CITY OF FORT LAUDERDALE

# DEVELOPMENT REVIEW COMMITTEE

## CASE COMMENT REPORT

CASE NO. UDP-S24025

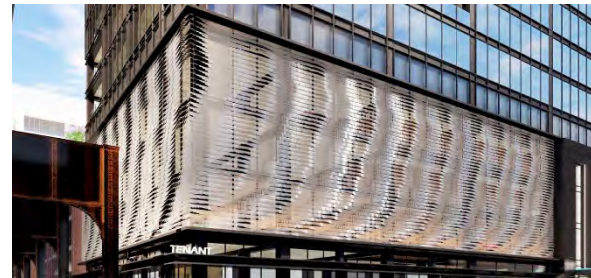
- k. **T5,** Additional details concerning the method of screening the parking garage is needed. Elevations do not indicate type of material to be used or method of how vehicle headlights will be screened.
- l. **T5,** Include parking for mopeds, scooters, motorcycles, and other similar vehicles.

**First Floor Double-Story Height**

**Parking Podium Screening**

**Building Corner Treatments**

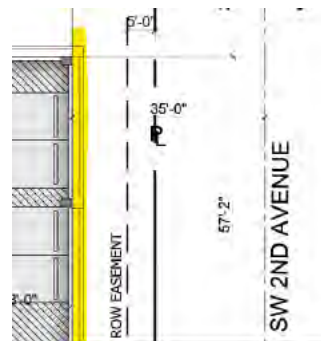
13. As designed and oriented, the building does not support allowing light and air at the street level. Also, the multistory parking podium is out of scale with the building and the narrow width of the SW 5<sup>th</sup> Street right-of-way. Discuss in narrative methods for adjusting the design to meeting Downtown Master Plan guidelines regarding building design.

- a. Label use of space on all floors.
- b. Balconies cannot be placed in the setback unless fully open on all sides.
- c. Show end points of 15' dimension on northeast corner on Sheet A102.
- d. Label, provide dimension and setbacks for architectural features and balconies on floor plans.
- e. Garage screening should be located within the required setback. Identify line work (highlighted in yellow below) within setback on floor plans.
